SERVICE BULLETIN TE1906

Subject: Regarding pinbolt on 120° flyboom bucket support

(flyboom EO-05-14-14 L=1850mm, EO-05-14-16 L=2010

Repair kit to remove bending stresses in pin and in the bucket bracket 05-10227-33-01.

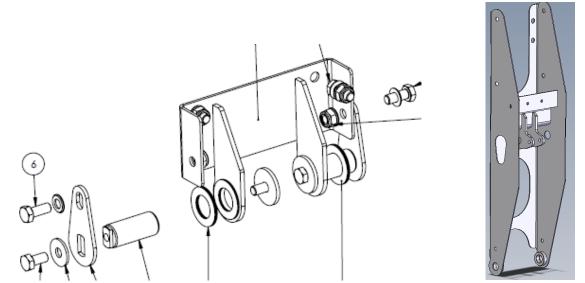
Versalift Denmark has learned that there can be problems related to the pin bolts in the bucket support bracket. This appears in the earlier versions of the 120° flyboom (for ETL lifts).

2 pins version

1 pin system (pin machined)

A repair kit RK-05-14-02 has been made to create a fork yoke to remove movement and bending stresses. Replace old system with this repair kit RK-05-14-02. Additional 2 new holes must be drilled in back of the bucket bracket – see RK-05-14-02 Mounting Instruction and drawing 05-10227-47-01.

What to check daily and every 14 day:

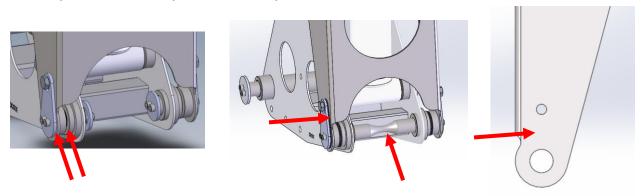
Enduser must do daily checks after the guidelines in the **Service Manual**. It is additional recommended to check the affected pinbolts, bucket bracket and bushings for cracks for every 14th days. If cracks or defects are detected the lift must not be used before it has been repaired with new parts or with repair kit RK-05-14-02.
